# Evaluation of Physical Barriers – RCA Office

Address: 3403 Tenth Street, Suite 320, Riverside, 92501

Evaluation Date: 07-19-2021

FLOOR PLAN OF RCA OFFICE- 3<sup>rd</sup> Floor

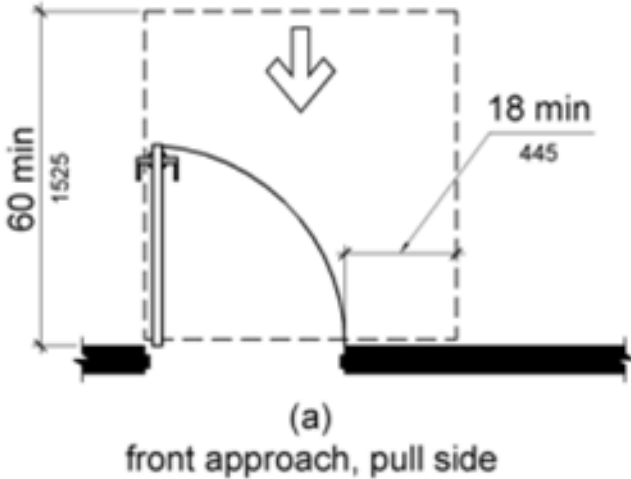
Issues/ Barriers Identified	Recommendations	Comments/ ADA Requirements
<b>1. Entry Doors</b>		
I. ISA sign is missing at accessible entry doors. Directional sign pointing to accessible route is missing at the inaccessible main door	Provide ADA compliant signage at accessible entry doors, exit doors, and provide directional signage at all inaccessible doors	216.6 Entrances. Where not all entrances comply with 404, entrances complying with 404 shall be identified by the International Symbol of Accessibility complying with 703.7.2.1. Directional signs complying with 703.5 that indicate the location of the nearest entrance complying with 404 shall be provided at entrances that do not comply with 404. 216.4.3 Directional Signs. Signs required by section 1003.2.13.6 of the International Building Code (2000 edition) or section 1007.7 of the International Building Code (2003 edition) (incorporated by reference, see "Referenced Standards" in Chapter 1) to provide directions to accessible means of egress shall comply with 703.5.

<b>2. Exit Doors</b>		
I. The accessible door with closer (near the stairs) closes too fast	Adjust door closers on all doors on the accessible route.	404.2.8 Closing Speed. Door and gate closing speed shall comply with 404.2.8. Door closers and gate closers shall be adjusted so that from an open position of 90 degrees, the time required to move the door to a position of 12 degrees from the latch is 5 seconds minimum
II. Maneuvering clearance to the breakroom door from inside is blocked by the water dispenser. Access to the paper towel dispenser is also blocked.  	Relocate water dispenser to provide 18 inches on latch side per 404.2.4 for times when a closed door needs to be opened from inside.	
<b>3. Exterior Accessible route</b>		No issues found. Maintenance of exterior route to the building is the responsibility of County of Riverside who lease the third floor to RCA

Issues/ Barriers Identified	Recommendations	Comments/ ADA Requirements
<b>4. Common Use Areas</b>		
a. Entry Lobby		
i. Knee and toe clearances are not adequate at the reception desk 	Provide accessible writing/working surface at the reception counter that is available to general public.	 <p>226.1: Where work surfaces are provided for use by other than employees, at least 5 percent shall comply with 902</p>
ii. Wheelchair space is not provided in the lobby 	Relocate furniture to allow space for at least one wheelchair or (5% of the total number of chairs , whichever is higher)

d. Controls for lighting and thermostats etc.		Access to thermostat is blocked by the printer
<b>5. Restrooms</b>		Not Applicable in this facility. Restrooms are maintained by the County of Riverside

Issues/ Barriers Identified	Recommendations	Comments/ ADA Requirements
<p><b>6. Break Room</b></p> <p>i. <b>Break Room Counters:</b> Obstructed high side reach over 36 inch high and 25.5 inch deep break room counter does not comply with 308.3.2.</p> 	<p>Modify break room counters to allow compliant access to the sink faucet and operable parts/ controls that are at the back of counters</p>	<p>308.3.2 Obstructed High Reach. Where a clear floor or ground space allows a parallel approach to an element and the high side reach is over an obstruction, the height of the obstruction shall be 34 inches (865 mm) maximum and the depth of the obstruction shall be 24 inches (610 mm) maximum.</p>  <p>308.3.2</p>
<p>ii. A 36 inches wide accessible route to the break room counter is not available due to chairs and tables.</p>	<p>Relocate furniture to provide an accessible route.</p>	
<p><b>7. Conference Meeting Rooms</b></p>		<p>No issues found</p>
